REVISED RESPONSE TO REQUEST FOR ADDITIONAL INFORMATION**APR1400 Design Certification****Korea Electric Power Corporation / Korea Hydro & Nuclear Power Co., LTD****Docket No. 52-046**

RAI No.: 132-8088

SRP Section: 11.05 - Process and Effluent Radiological Monitoring Instrumentation and Sampling System

Question No. 11.05-2

Figure 11.5-2AA Location of Radiation Monitors at Plant (Wastewater Treatment FAC. El. 82'-0")

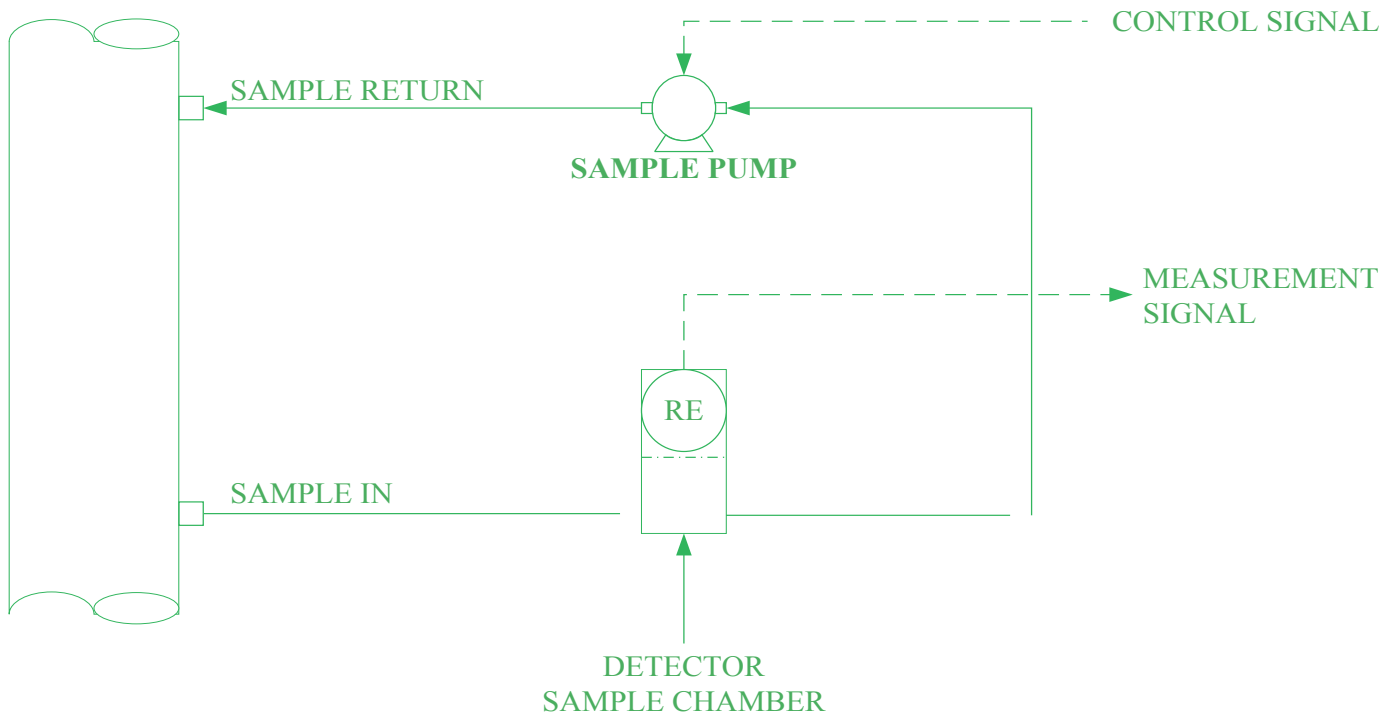
Figures 11.5-2 will be revised to show the correct location of the radiation detectors (RE) and the monitor electronics/displays (RT). In the figures, RE/RT means that the detector and electronic/display are installed together adjacent to each other. The location of some RE and RT have been changed to the correct location. Subsection 11.5.2.3.5 will be added to describe that the location of each monitor is shown in Figures 11.5-2.

The monitor is located in Wastewater treatment facility as shown in Figure 11.5-2AA.
